MEMORANDUM

To: John Norquist, Nora Beck
From: Lucinda E. Gibson, P.E. and Norman L. Marshall
Date: 21 August 2007
Re: Update on Buffalo Skyway Project

Summary of Current NYSDOT Plans for Buffalo's Waterfront.

Figure 2: Excerpt of NYSDOT Preferred Alternative ("Modified Alternative") near Skyway Touchdown

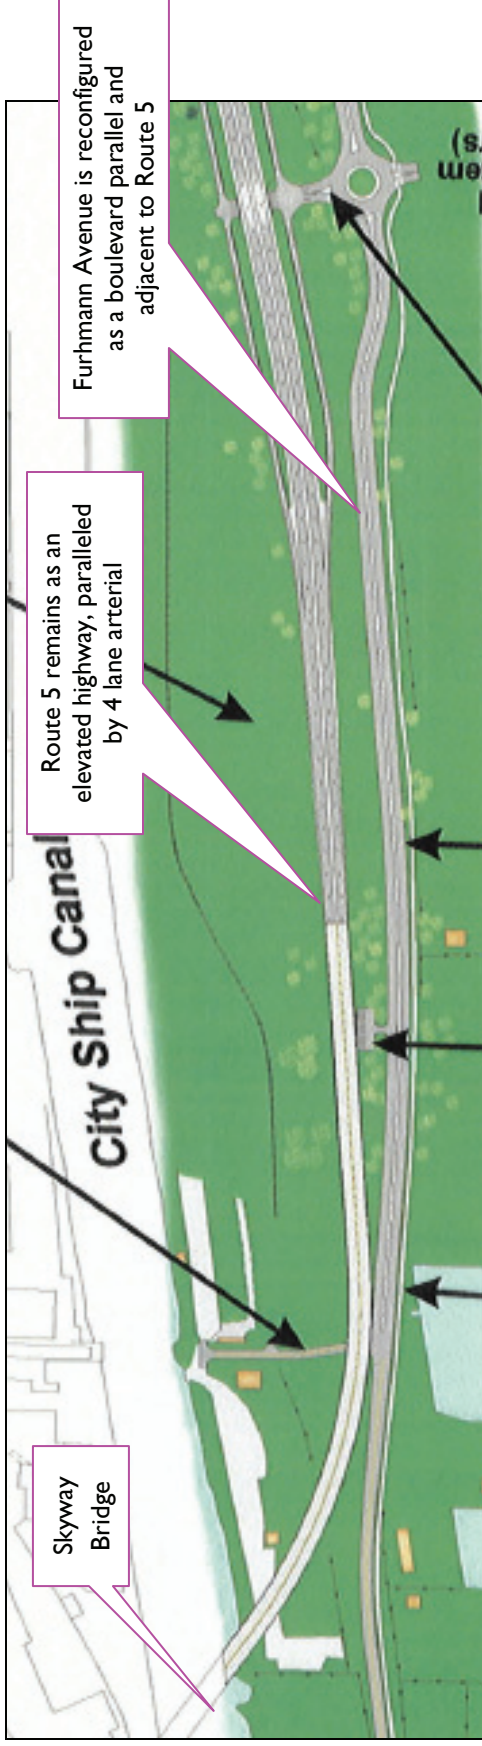
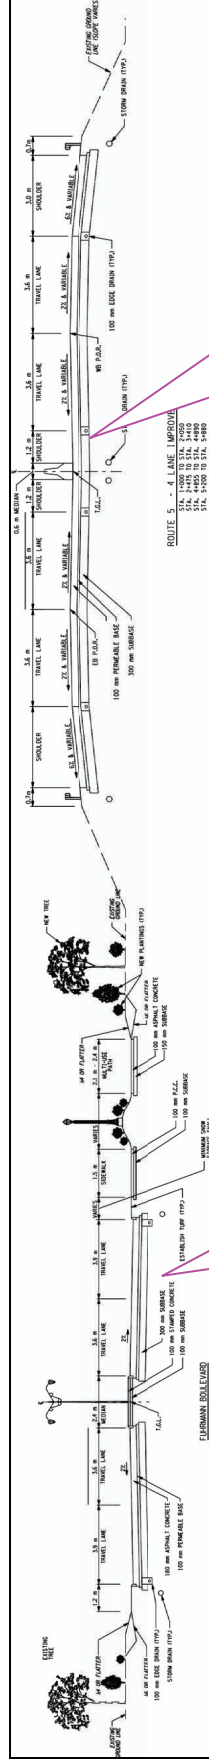
The construction contract under consideration for letting this fall would reconstruct Fuhrmann Avenue as a four-lane “boulevard”, but leave Route 5 as a high-speed freeway. This means that there would be two parallel facilities, which is a waste of limited land and money. Even worse, the design of the boulevard as proposed by NYSDOT will not be able to fulfill the promise for attracting walkable urban redevelopment because it will only have development on one side with limited connectivity to the rest of the city. The other side will have an unsightly, elevated, noisy, high-speed highway.

Figure 2, from the Southtowns Connector EIS, shows the proposed cross-section of Route 5 under the “Modified Improvement” alternative. It is a four-lane, limited-access, high-speed highway with a jersey barrier median and guardrails. This high-speed facility would be paralleled by the Fuhrmann Avenue “Boulevard”.

Route 5 remains a limited access highway atop an embankment

Figure 3: NYSDOT Boulevard Alternative near Skyway

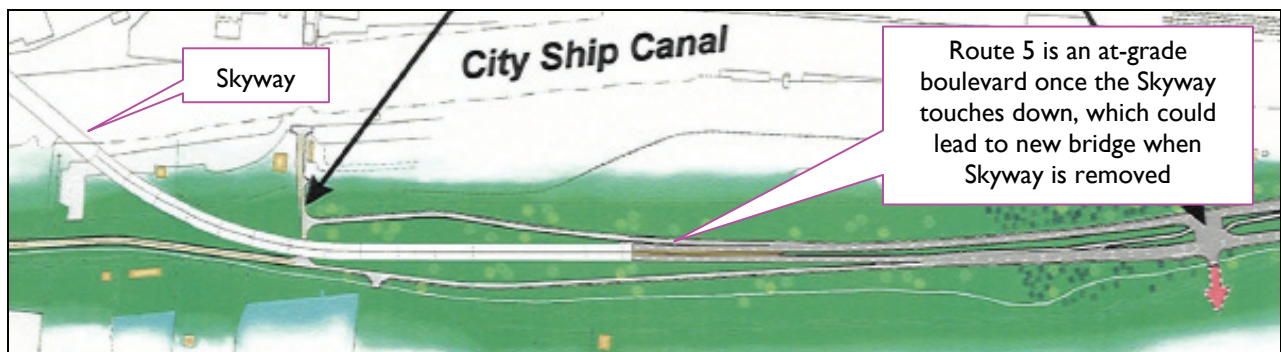
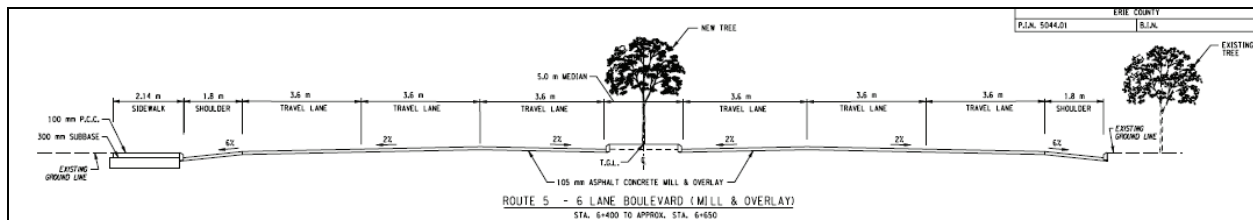
The EIS also considered a “Boulevard” alternative and concluded that this alternative is feasible. But for reasons not stated anywhere in the EIS, it was not chosen as the preferred alternative. The “Boulevard” alternative is far superior to the “Modified Improvement” alternative because it can easily be adapted to the removal of the Skyway Bridge, building a new grade level bridge connection to downtown Buffalo, and reconfiguration of the Fuhrmann Ave/Route 5 corridor into a multimodal street. Because the Skyway Bridge is currently under study to determine options for its future, which should include an exploration of “downsizing” to an at-grade facility, it would be prudent for NYSDOT to pursue the Boulevard alternative at this time, as it is most adaptable to a range of strategies for the Outer Harbor. In the Boulevard alternative, Route 5 transitions from the Skyway Bridge into a single 6-lane boulevard (see Figure 3). This plan is highly compatible with removing the Skyway Bridge and constructing a new at-grade bridge, which could be in one of several possible locations.

I have reviewed the EIS for documentation on why the NYSDOT “Modified Improvement” alternative was selected over the “Boulevard” alternative and could not find any discussion of this decision. The “Boulevard” alternative performed essentially the same in terms of traffic operations and better in terms of economic development, because less area is consumed by roadway and can be redeveloped. The only traffic reason that it did not perform as well was that there was a slight diversion of traffic onto I-90 and I-190, due to the boulevard having slightly higher travel time, since it would be a 40 mph street. However, this is a relatively minor issue, especially since there has already been diversion to these roads since the elimination of tolls.

Figure 4: NYSDOT Preferred Alternative (“Modified Alternative”) at Ohio Street

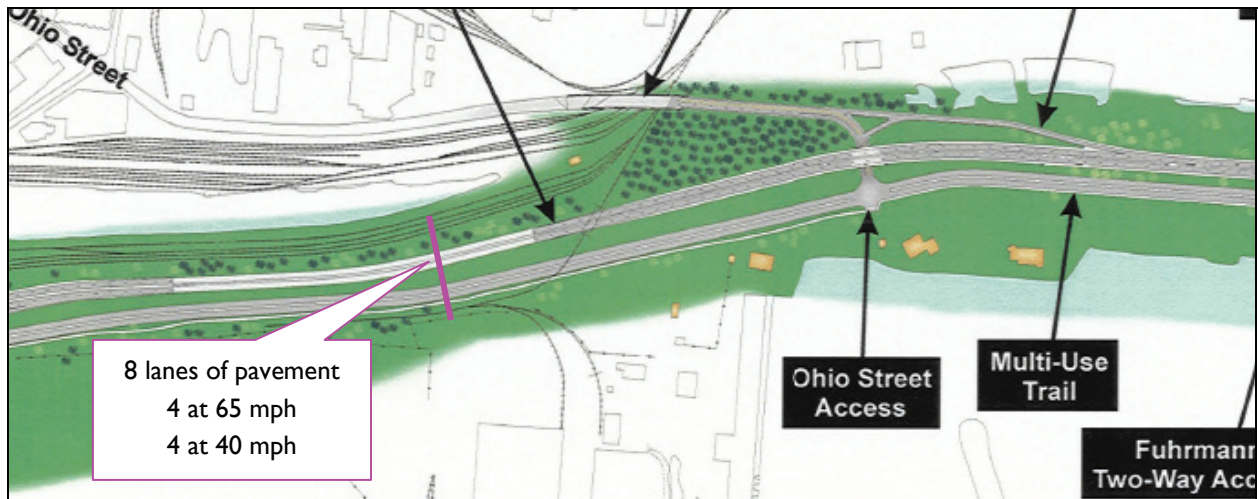
Figures 4 and 5 show another comparison of the two alternatives at the Ohio Street intersection. The NYSDOT “Modified Improvement” alternative includes 8 lanes of pavement in an area where redevelopment is hoped for, with 4 of these lanes high speed, elevated, and noisy. Our preferred alternative would be a four-lane avenue with a design speed of 35 mph. The future traffic projections indicate that 4 lanes would provide sufficient capacity for an urban setting.

Figure 6: Comparison of the Proposed NYS DOT Boulevard Cross Section with a Four Lane Avenue Cross Section

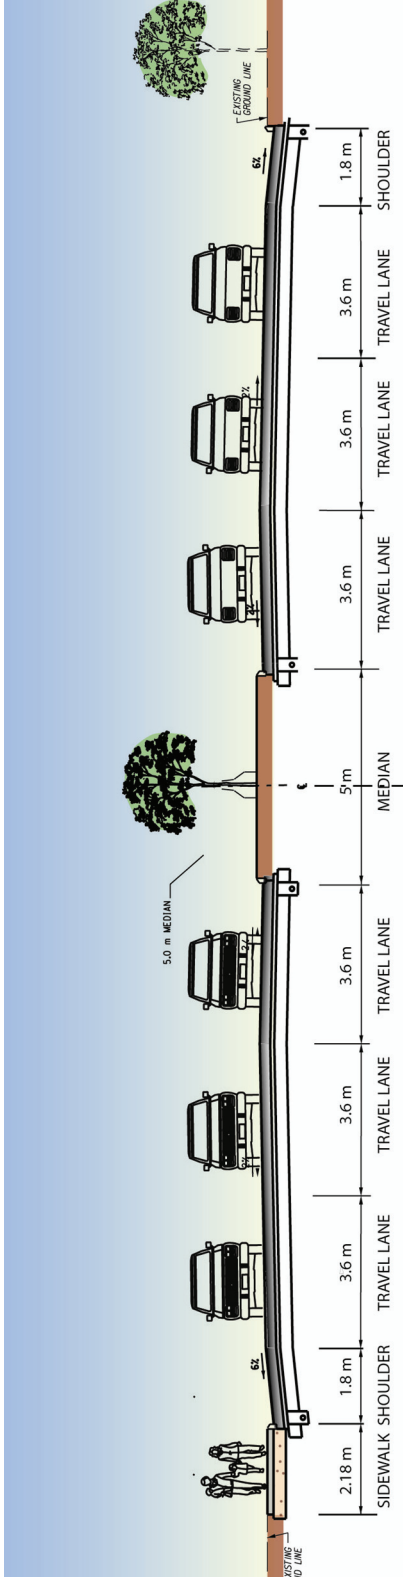
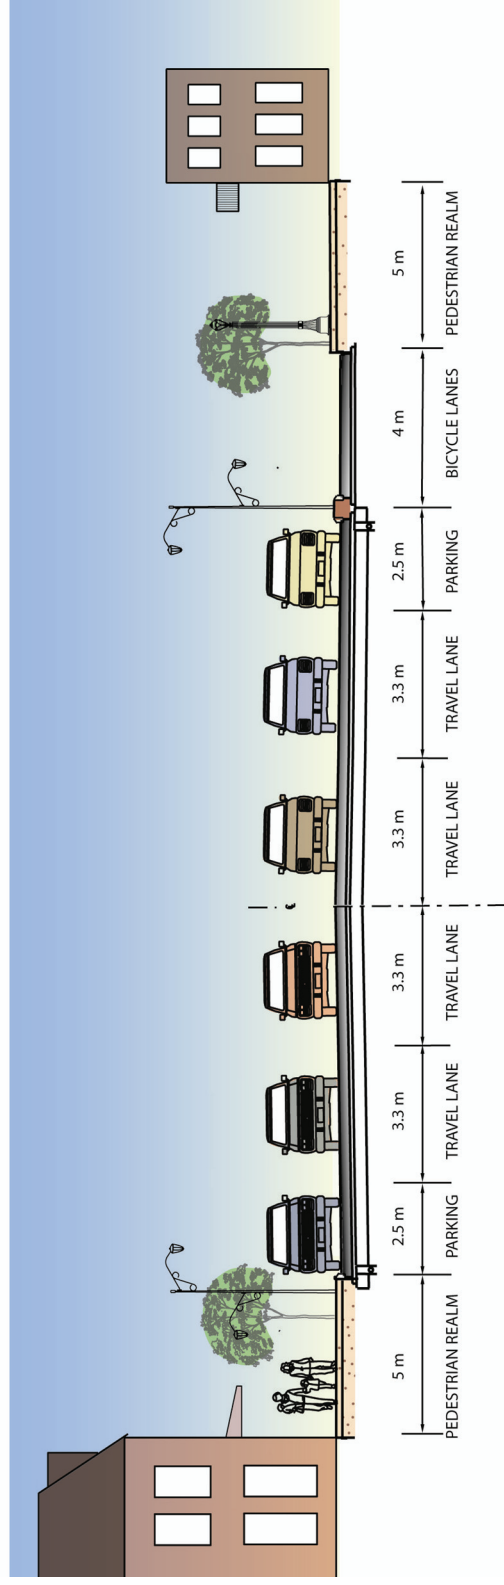
The specifics of the design of the Boulevard in the “Boulevard Alternative” leave ample room for improvement. The NYSDOT design for the “boulevard” is a 6-lane arterial with a landscaped median. The traffic volumes for the boulevard alternative (scenario 7) do not exceed 2,500 vehicles per hour (vph) in the peak hour/peak direction. A four-lane avenue design would provide sufficient peak hour capacity. Further, these traffic projections were prepared before the toll elimination on I-190, so actual traffic volumes are likely to be even lower. Figure 6 compares the proposed NYSDOT “Boulevard Alternative” cross-section of Route 5 with our recommended cross-section as a four-lane avenue. This avenue design is consistent with the guidelines in the recently published *Context Sensitive Solutions for Major Urban Thoroughfares*, a Recommended Practice published by the Institute for Transportation Engineers (ITE).

The design of the boulevard will be critical to achieving the goal of the Outer Harbor becoming a vibrant, urban place. The NYSDOT “boulevard” plan is essentially designed for creating a pleasant, tree-line road to drive through, but it does not support pedestrian transportation nor urban redevelopment. The NYSDOT design assumes that all access will be off from the main boulevard, and does not integrate pedestrians or urban development into its design.

Instead, our proposed cross section shown in Figure 6 would result in a facility that will provide adequate capacity for the moderate volumes of through traffic, and also provide an excellent stage for redevelopment. The plans for a bicycle facility along the Outer Harbor could be integrated into the boulevard design through the areas of focused urban development, in a way that will provide meaningful transportation alternatives, as well as provide an outstanding attraction for both residents and visitors to come to the Outer Harbor without their cars.
